Newsletter 18-11-15

Appendix. Trails at Murray Franklyn Development (SEPA 18-009)

Newcastle Trails supports the Trail Connection described on page 1 in the proposed Development Agreement with Murray Franklyn (**Recitals, E**): "a north-south pedestrian trail connection from the May Creek Trail to the 84th Street Trail and Horse Trail/CrossTown Trail system". But the trails the Agreement specifies will **not** complete a safe, direct Horse Trail connection to May Creek Park and Trail, as required by the Comprehensive Plan. And an alternate route may not be feasible.

Figure 1: Neighborhoods served by Trail Connection.

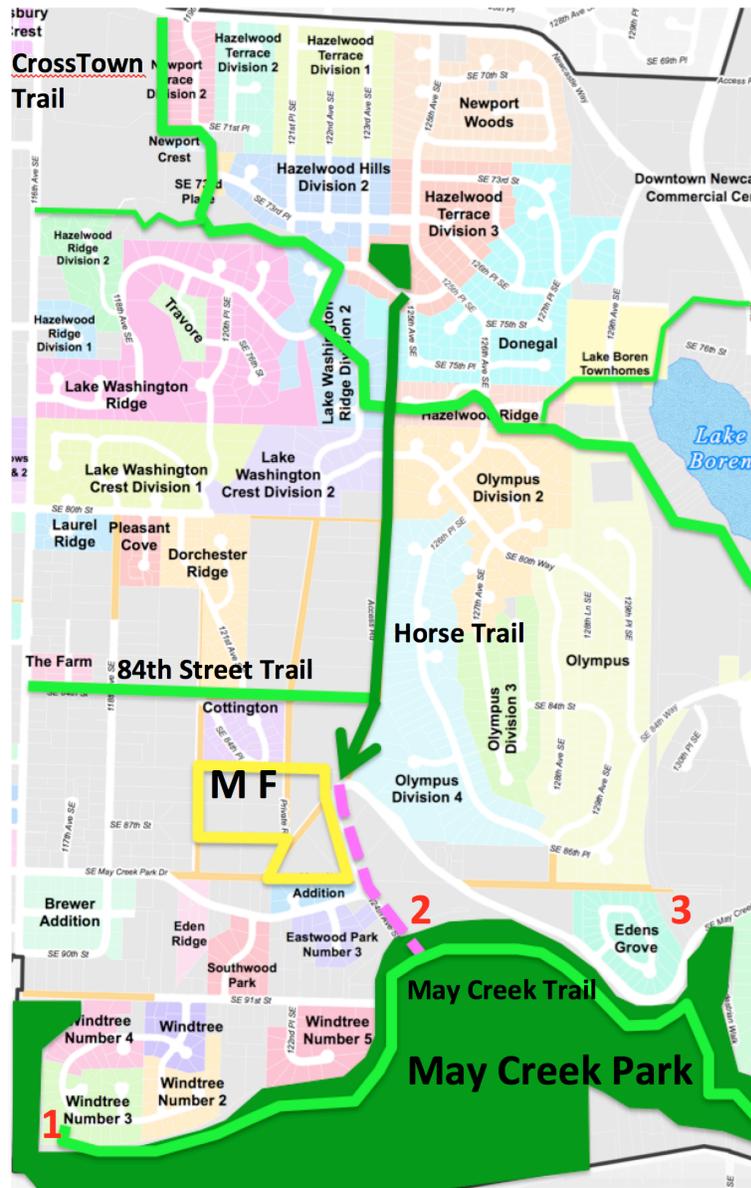
The map in Figure 1 shows how the north-to-south Horse Trail (dark green line) will provide pedestrian access to May Creek Park from many neighborhoods west of Lake Boren, if its final section (dashed magenta line) is completed as part of the Murray Franklyn project (yellow outline).

The park has 4 entry points from Newcastle. Entries 1-3 are shown on the map; entry 4 is on Coal Creek Parkway. Entry 1 has 43 descending steps; entries 2 and 3 require pedestrians to cross May Creek Park Drive, and entry 2 requires walkers to use the shoulder of this busy arterial. Safe access to entry 2 should be provided when the new development is built.

Figure 2. Conceptual Trail Exhibit from Murray Franklyn

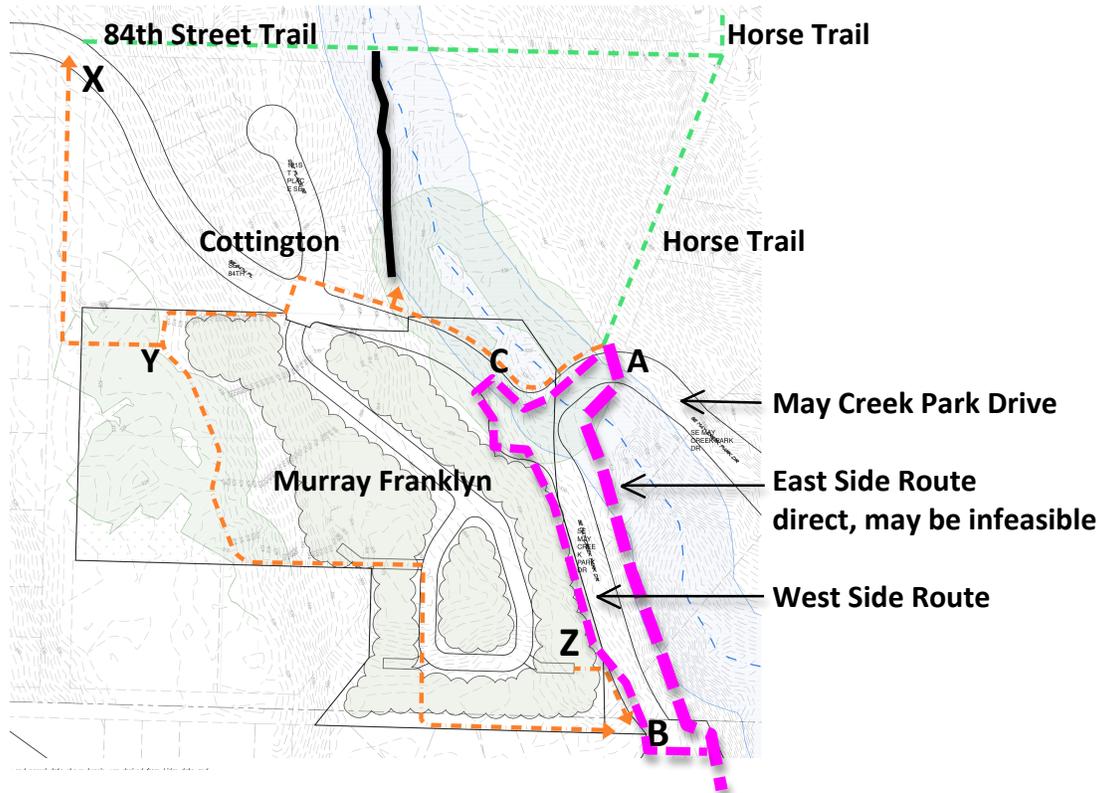
Figure 2 below shows the Conceptual Trail Exhibit referenced in section 2.b. I've added labels (in black) and three trail routes: an existing access trail (thick black line); and two proposed routes (dashed magenta) that would complete the Horse Trail as described in Newcastle's Comprehensive Plan. The most direct route follows the east side of May Creek Park Drive after crossing at A; the west-side route follows sidewalks west on the roundabout to C, with crossings at C and B.

The thinner dashed lines show the existing 84th Street Trail and Horse Trail (green), and the trails proposed by Murray Franklyn (red). The trail XYB satisfies the Agreement, but so does a trail on sidewalks from X to Z plus a soft surface trail Z to B. Both options would force Horse Trail users on a lengthy detour into Cottingham. And, since they stop at B, neither provides a safe connection to May Creek Park or May Creek Trail. Surely, any agreement that puts 47 homes near a park should provide for safe access to the park.

One Possible Solution. The **West Side Route** ACB shown in Figure 2 would provide a safe, reasonably direct Trail Connection to B at little cost to the developer. It would use sidewalks planned for the roundabout, and a soft-surface trail on the west side of May Creek Park Drive. The trail would cost little to build; and a trail in the existing right-of-way would not affect lot sizes. There's a possibility of some grade separation from the road (see Peggy Price's comments below).

There's a reasonable argument for putting the trail on the west side of SE May Creek Park Drive going by the Murray Franklyn development to take pedestrians between the Horse, Sylvan, and May Creek Trails. It would allow pedestrians coming south on the Horse Trail to cross MCP Dr. at a less confusing and congested location where the sight distance would be better--the rise immediately east of the SE corner of the Murray Franklyn development (an extension of the half-width road right of way owned by the City). That's where I prefer to cross because I can see traffic better, and they can see me better, even with the broad turn where the trail would go into May Creek Park along 124th Ave. SE. Pedestrians coming from the Horse Trail could cross the new road (SE 84th Place) just west of the traffic circle to go toward the May Creek Trail, so they wouldn't have to cross at the hairpin with its poor sight distance. South of the circle, the trail could be elevated on a terrace above the road, and it wouldn't have to be paved in that location. Another advantage of this plan is that the trail could be created relatively quickly and easily even if the street improvements were delayed, so pedestrians would have a reasonably safe route off the busy arterial. I hope this plan will be considered. I'd be OK with reducing the east setback of the affected lots to accommodate the trail.

A trail connection on the west side of May Creek Park Drive is important, because there may be no good alternative. Eventually the trail here should be an all-weather trail, perhaps asphalt, since it will get heavy use: it's the narrow part of a funnel bringing pedestrians by trail and sidewalk from all the neighborhoods to the north.

If the developer agreed to build trail ACB, the City could agree to provide a safe crossing at B and complete the trail into May Creek Park. It would follow the east side of 124th Ave SE, avoiding the homes and driveways on the west side, and could be built cheaply. Since the development would benefit from the trail connection, the developer could be asked to provide a portion of the normal impact fee to reimburse the City.
